Work Order ID 160362

Item ID: D350-607-541 Accept ***N900040100*** Setup Start ***NS1***
Revision ID: Stop ***NS2***
Item Name: AS350/AS355 Quick Release Heli-Utility-Basket™ Long, Heavy Duty Lid
Start Date: 5/24/2017 Start Qty: 1.00 ***1*** Cust Item ID:
Required Date: 6/5/2017 Req'd Qty: 1.00 ***1*** Customer:
Reference: SCHEDULED/C

DART SERVICE INSTRUCTION

TO AMEND INSTALLATION INSTRUCTIONS D350-607-3 Rev.D,
INSTALLATION INSTRUCTIONS D350-607-4 Rev. C AND
INSTRUCTIONS FOR CONTINUED AIRWORTHINESS ICA-D350-607 REV. 6

FIGURE 1: INSTALLATION OF D4775-041 FWD STRUT

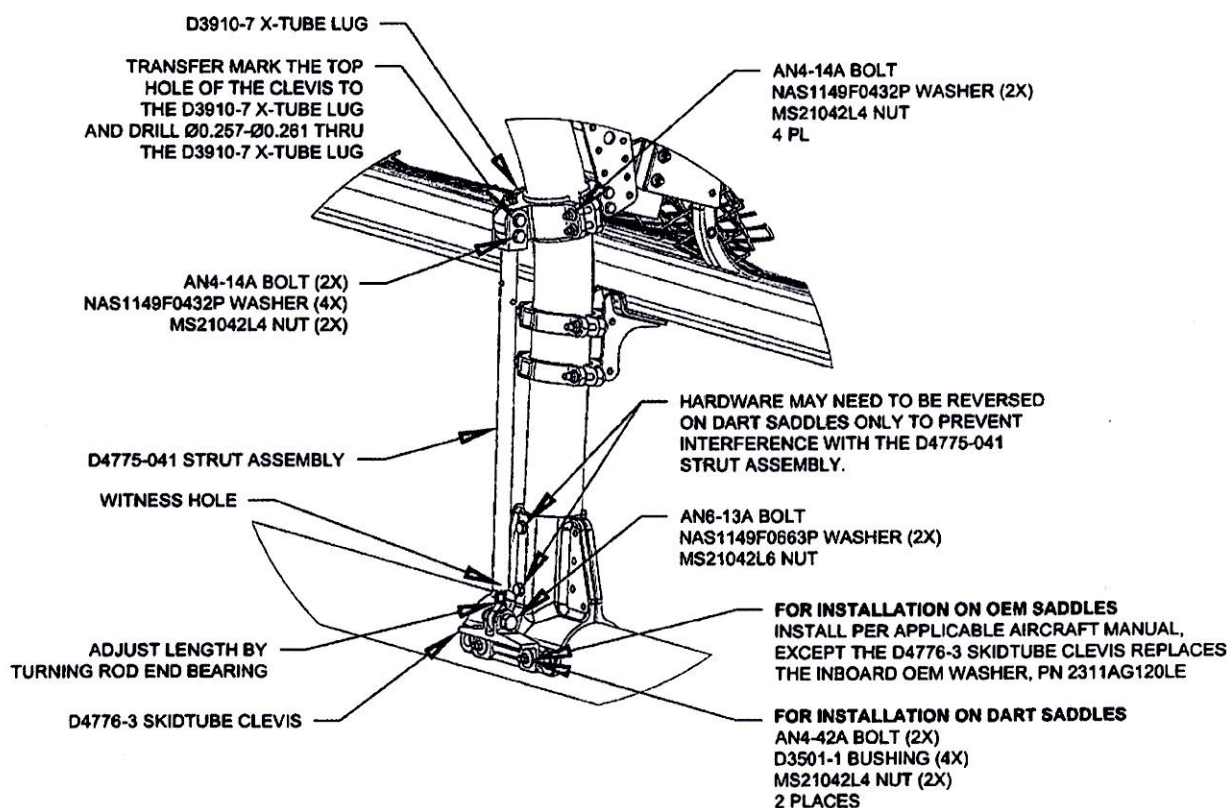
3.1 Substitute the Forward Lower D3910-5 X-Tube Lug with the D3910-7 X-Tube Lug as shown in Figure 1.

3.2 Install the forward D4775-041 Strut Assembly. Transfer mark from the upper hole on the clevis of the D4775-041 Strut Assembly to the D3910-7 X-tube Lug and drill thru the lug $\varnothing 0.257$ - $\varnothing 0.261$ as shown in Figure 1. Touch up chemical conversion coating per MIL-DTL-5541. Check the witness holes located at the bottom end of the D4775-041 Strut Assemblies to ensure that the thread from the rod end extends past the witness hole.
Torque MS21042L4/-4 nuts to 50-70 in-lbs (5.7-7.9 N-m). Torque MS21042L6/-6 nuts to 160-190 in-lbs (18.1-21.5 N-m).
